PROPOSAL REQUEST (PR)

PROJECT NAME ERC Residential Program and PHP		ARCHITECT'S PROJECT NO. 132258.00
PR NO. 09		FILE CODE G1-Documents
DATE ISSUED 03 18 2014	CONTRACT FOR General Construction	CONTRACT DATED
ARCHITECT Boulder Associates, Inc. 1426 Pearl Street, Suite 300 Boulder, CO 80302	CONTRACTOR GH Phipps 5995 Greenwood Plaza Blvd. Suite 100 Greenwood Village, CO 80111	OWNER Eating Recovery Center 7351 E. Lowry Blvd Suite 200 Denver, CO 80230

This PR documents the changes marked-up / revised per the casework, fireplace, and teaching kitchen hood, and kitchen submittals.

A2.2B

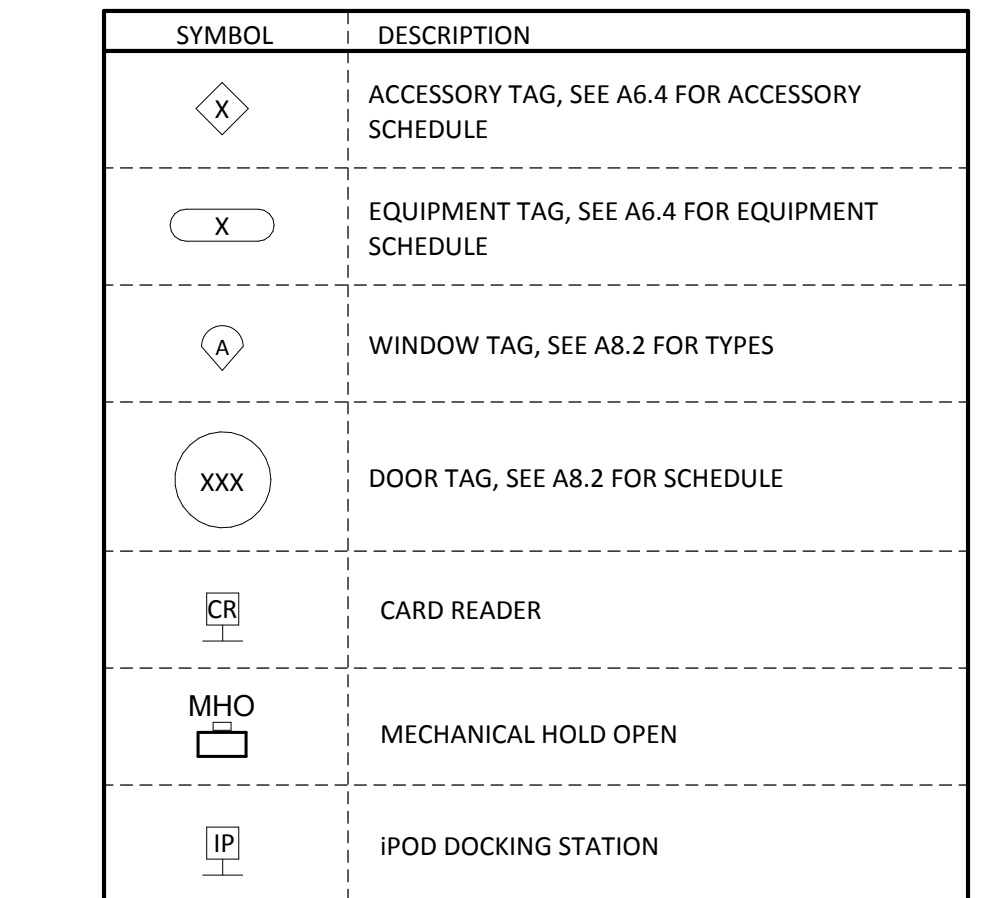
5. Changed sink casework type in rooms 185 and 292 to "S21" in lieu of "S03" See elevations 23/A6.2 and 12/A6.4
6. Changed depth of shelving to 24" deep in lieu of 18" at back wall of rooms 249, 252, and 254 per owner request. See A2.2B

A6.2

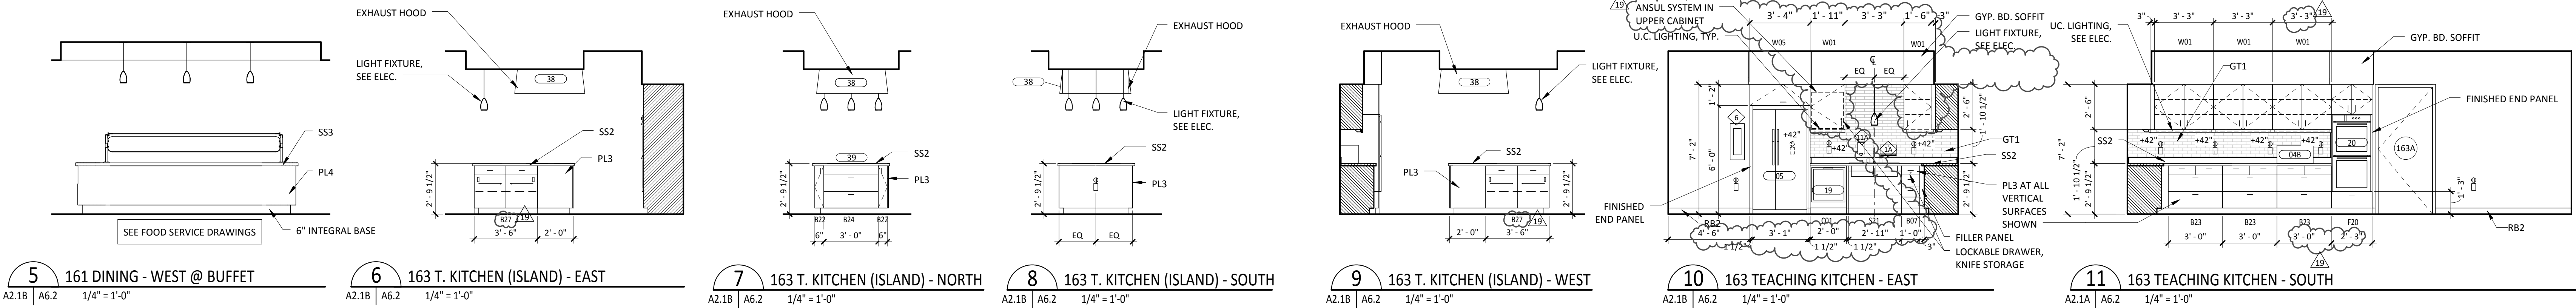
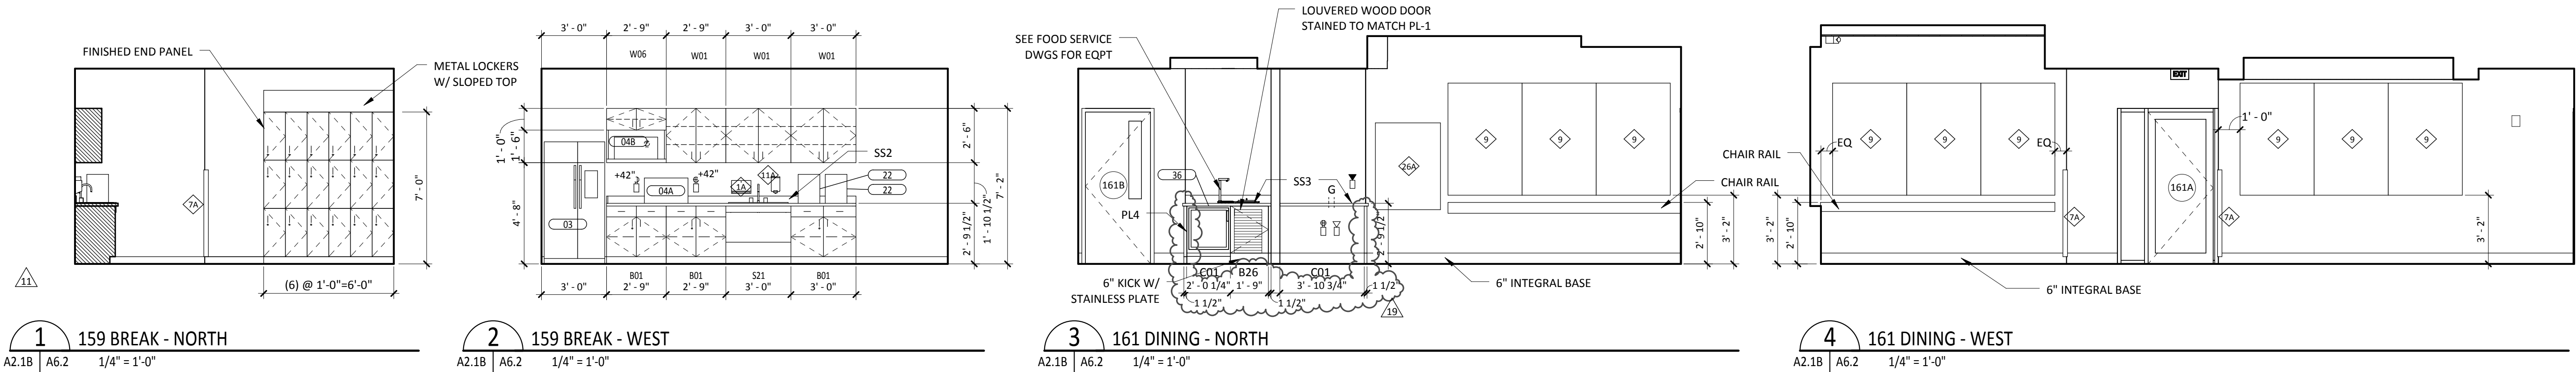
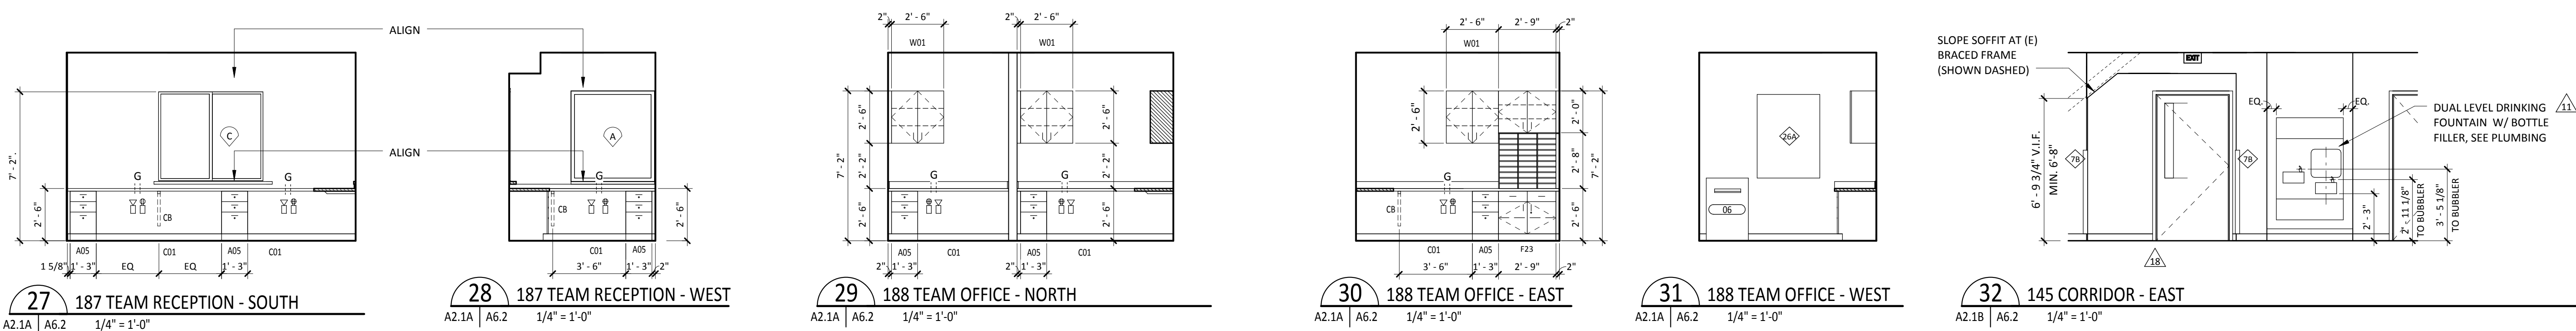
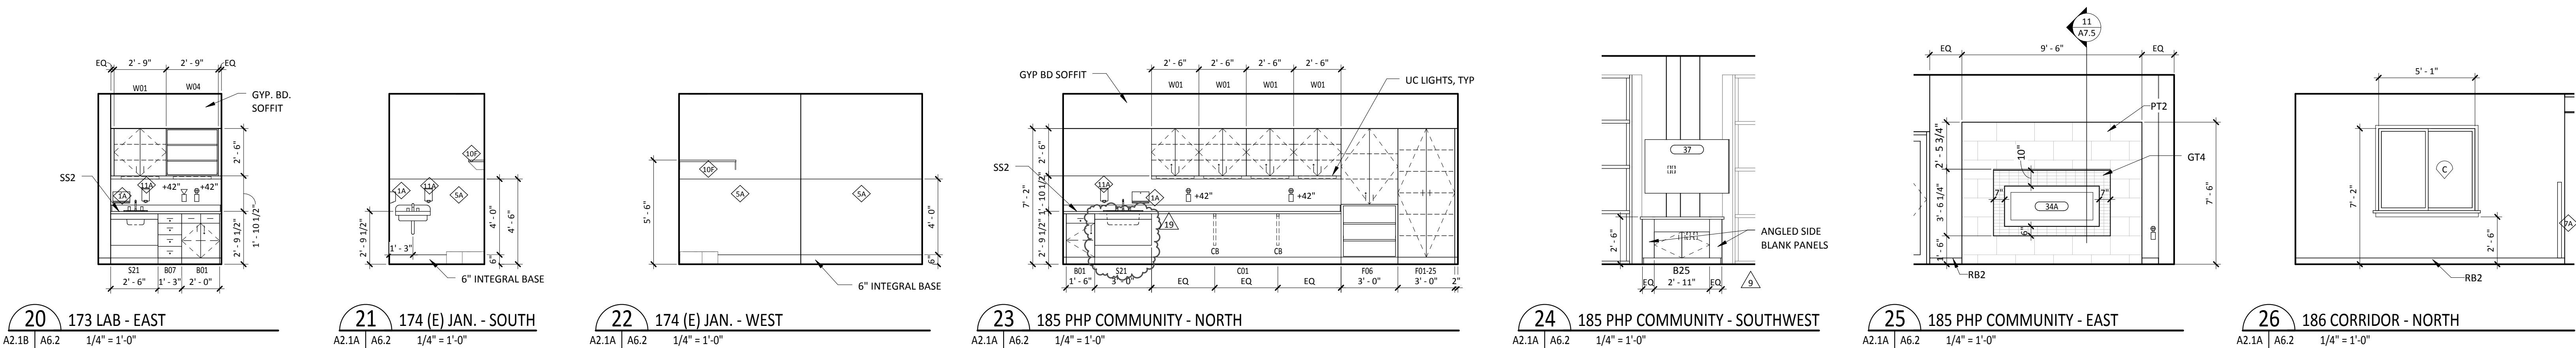
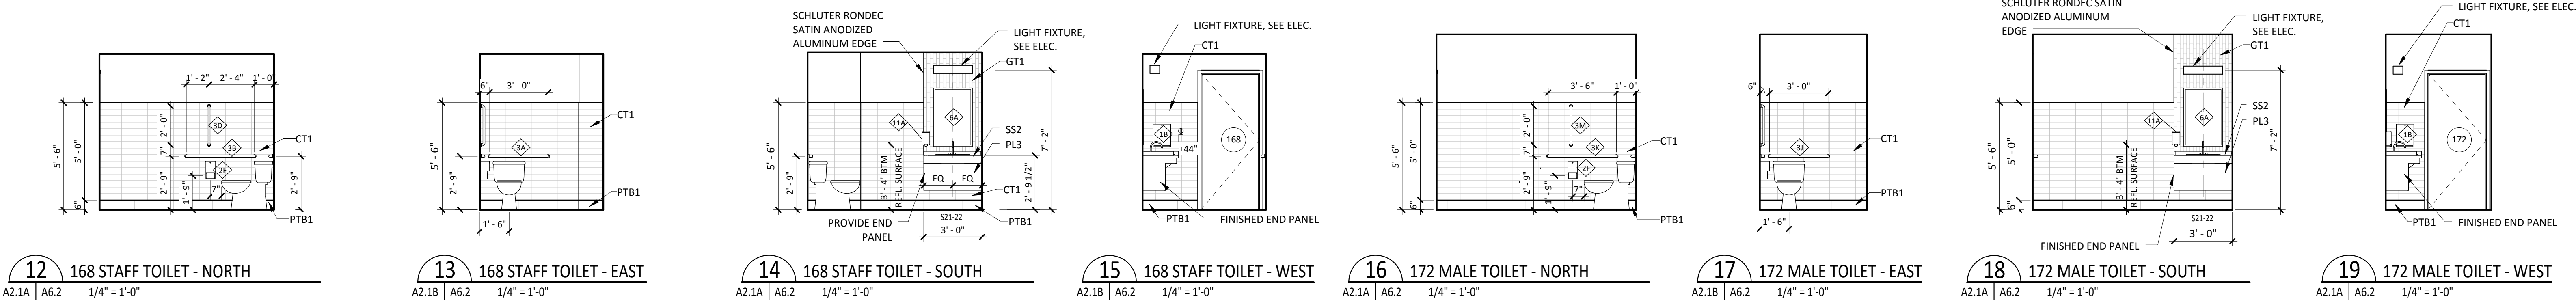
1. Added casework type "B26" to provide required food service legs as required by code in Dining 161. See 3/A6.2 and 17/A7.4
2. Added finished p-lam panel at East side counter in 161 and clarified dimensions. See 3/A6.2

3. Added casework type "B27" to clarify with the sliding casework doors shown in elevations 6 & 9/A6.2 and 18/A7.4
4. Revised East elevation of Teaching Kitchen (10/A6.2) to provide required side approach door clearance and revised location of the Ansul system box to fit in cabinet (21"W x 24"H x 8" D)

A6.4

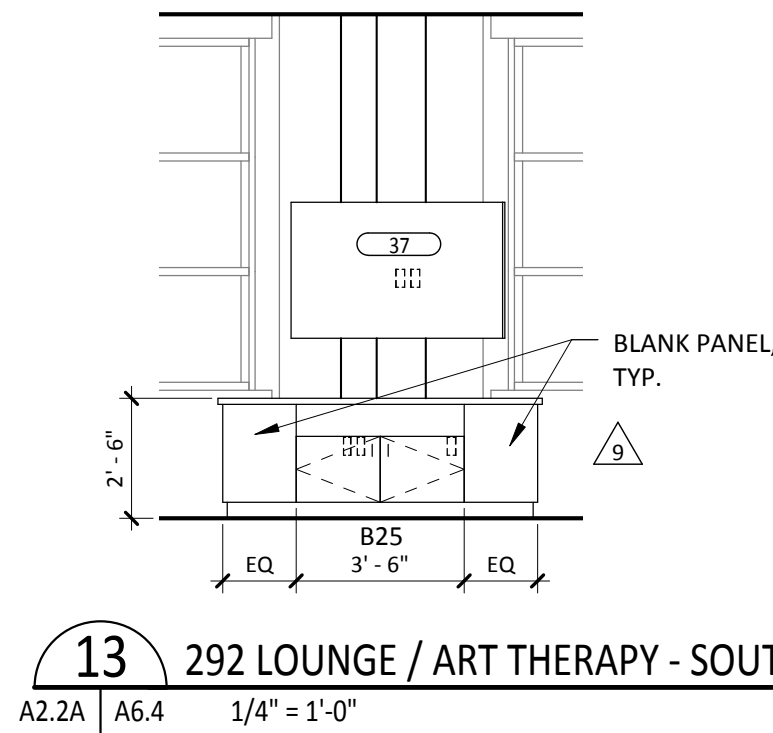
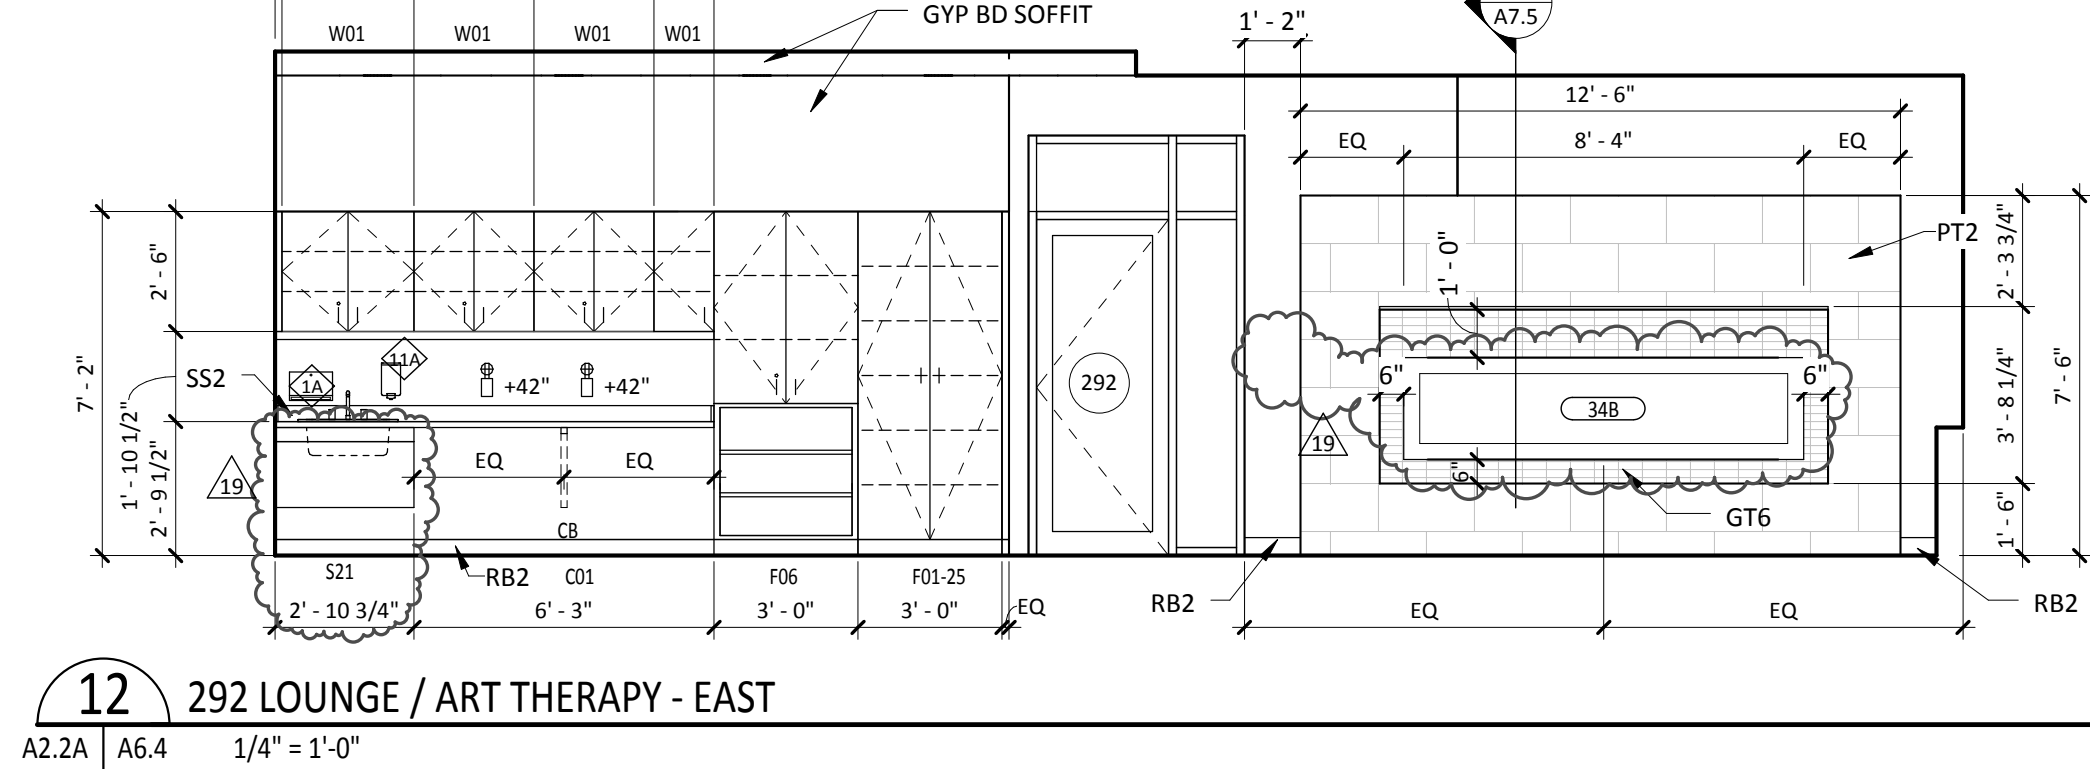
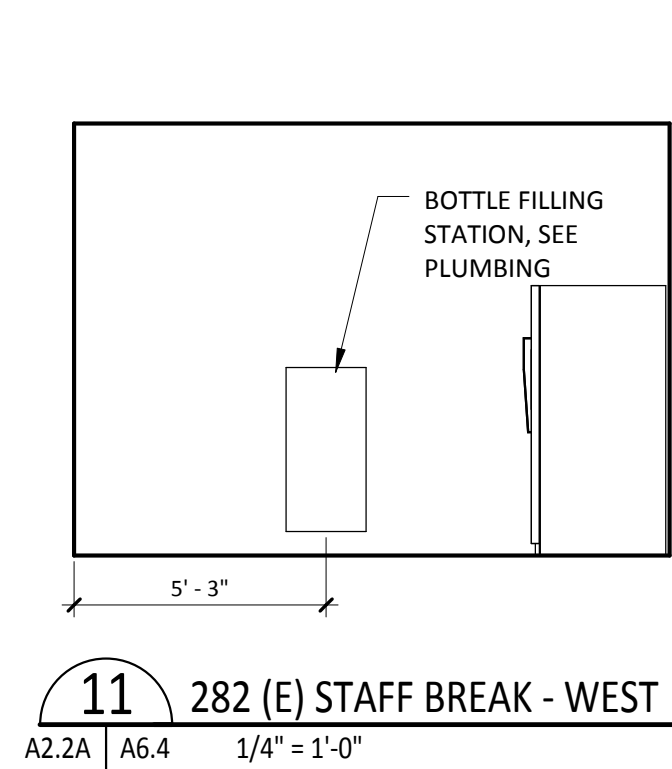
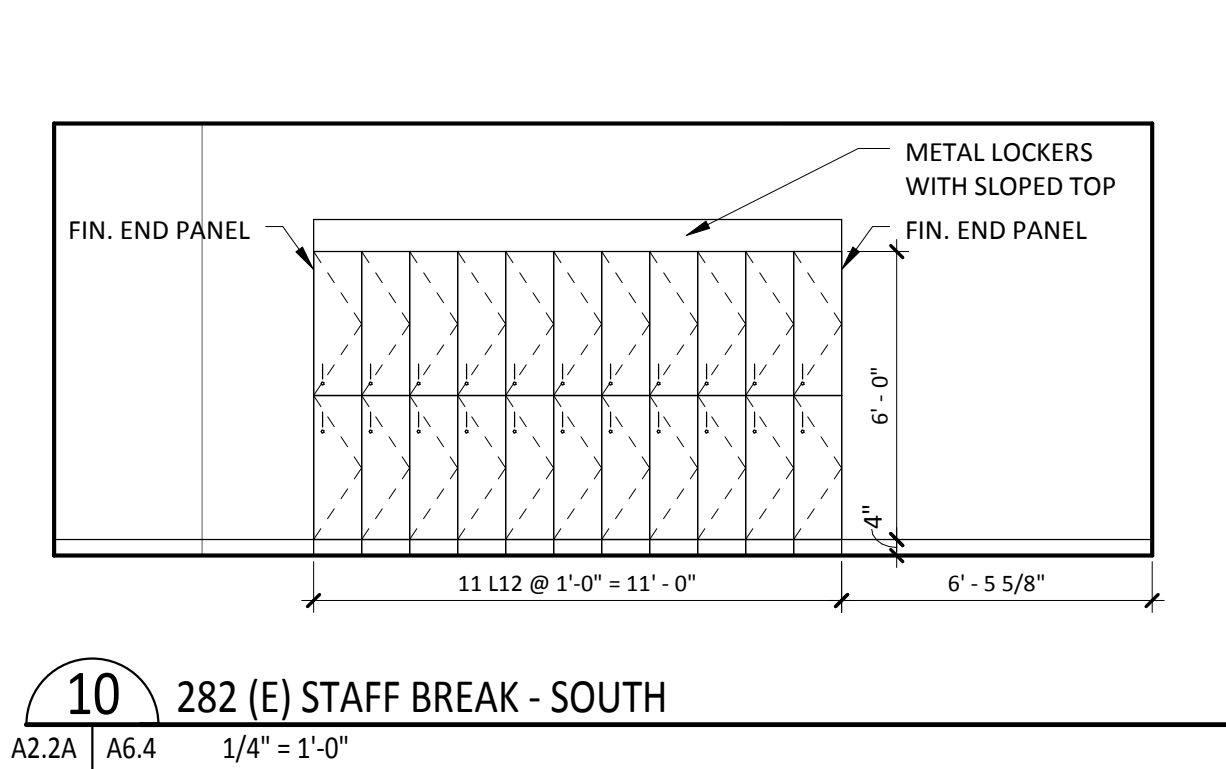
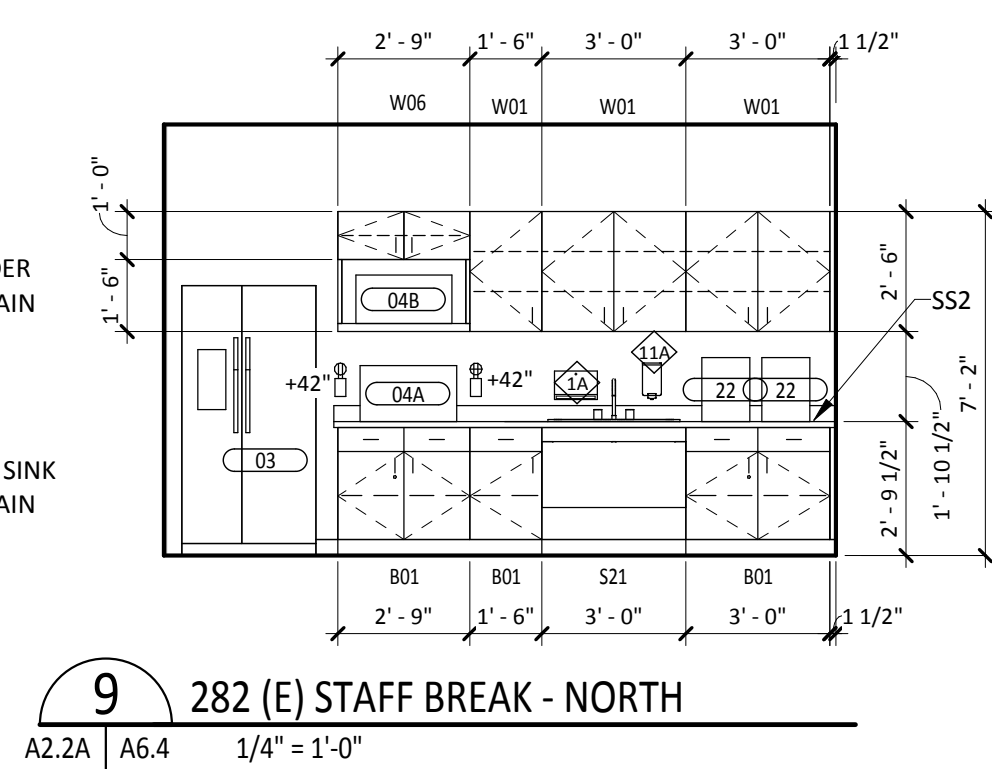
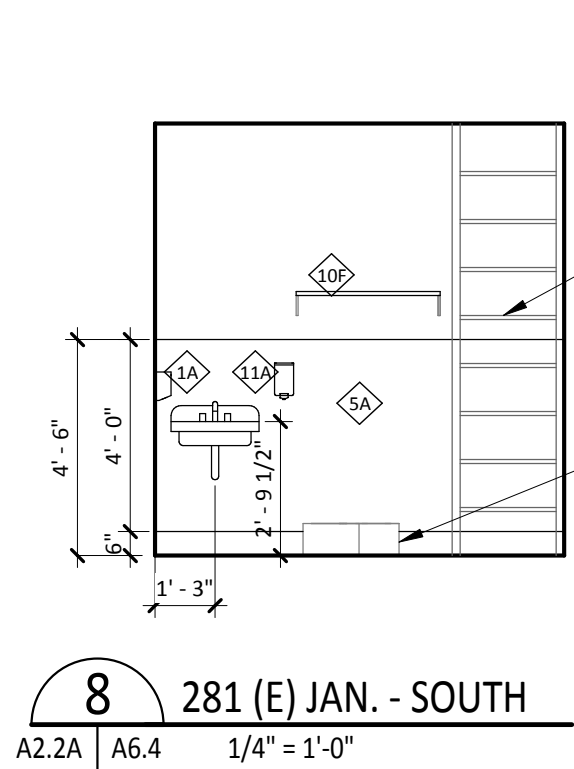
7. Modified counters at coiling counter doors in Meds Rooms 275 and 276 to be 4" deep in lieu of 24" on room side. See 1, 3, & 5/A6.4 and
8. Revised fireplace type and elevation in room 292, per returned fireplace submittal. See 12/A6.4.
